Form 3160-5 (June 2019)

UNITED STATES DEPARTMENT OF THE INTERIOR BUREAU OF LAND MANAGEMENT

Revised Permit Information 11/08/2023:

Well Name: Audacious 19 Fed Com 302H

1722' Revised Wellbore B: KB: 3476' 2367' GL: 3451'

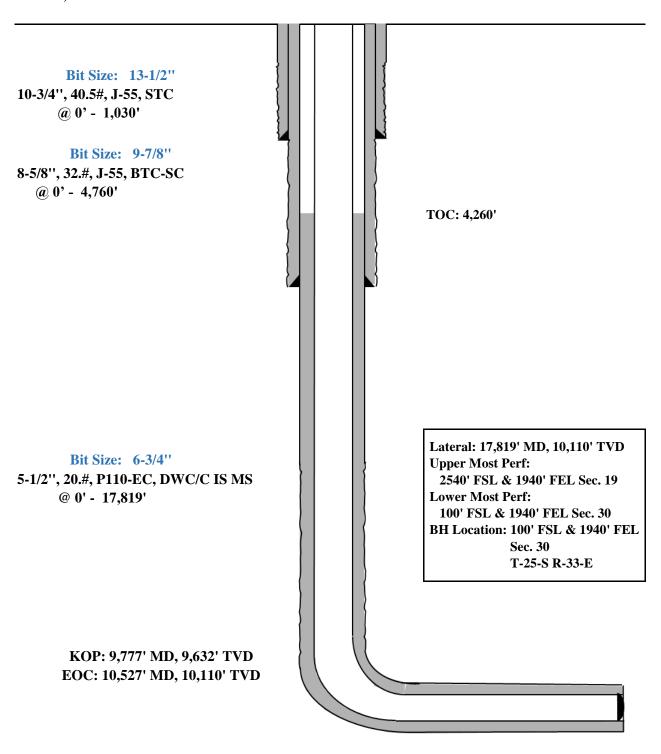
Change target formation to First Bone Spring Sands.

Update casing and cement program to current design.

1. CASING PROGRAM B:

Variance is requested to waive the centralizer requirements for the 8-5/8" casing in the 9-7/8" hole size. An expansion additive will be utilized, in the cement slurry, for the entire length of the 9-7/8" hole interval to maximize cement bond and zonal isolation.

Variance is also requested to waive any centralizer requirements for the 5-1/2" casing in the 6-3/4" hole size. An expansion additive will be utilized, in the cement slurry, for the entire length of the 6-3/4" hole interval to maximize cement bond and zonal isolation.

EOG requests permission to allow deviation from the 0.422" annulus clearance requirement for the intermediate (salt) section from Onshore Order #2 under the following conditions:

1722' FSL Revised Wellbore A:

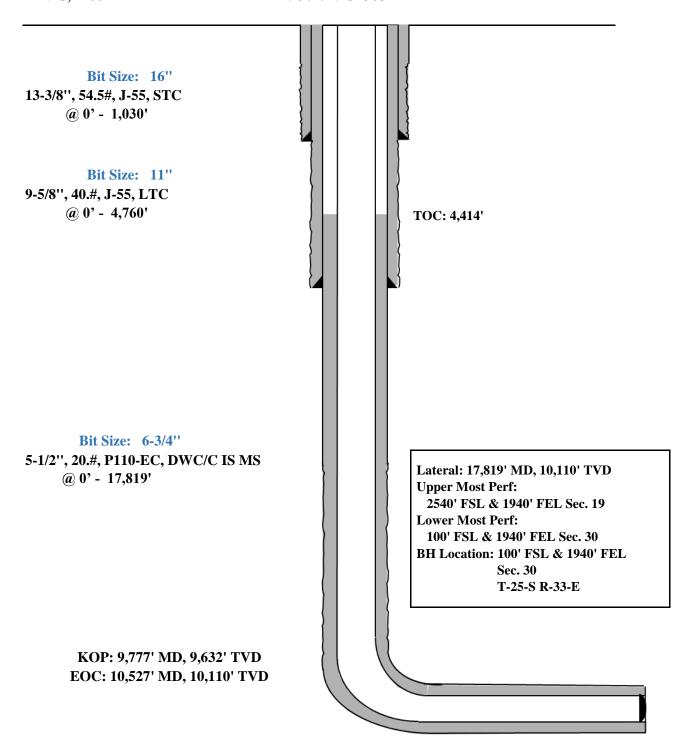
With horizontal flowing and gas lifted wells an end of tubing depth placed at or slightly above KOP is a conservative way to ensure the tubing stays clean from debris, plugging, and allows for fewer well interventions post offset completion. The deeper the tubulars are run into the curve, the higher the probability is that the tubing will become stuck in sand and or well debris as the well produces over time. An additional consideration for EOT placement during artificial lift installations is avoiding the high dog leg severity and inclinations found in the curve section of the wellbore to help improve reliability and performance. Dog leg severity and inclinations tend not to hamper gas lifted or flowing wells, but they do effect other forms of artificial lift like rod pump or ESP (electric submersible pump). Keeping the EOT above KOP is an industry best practice for those respective forms of artificial lift.
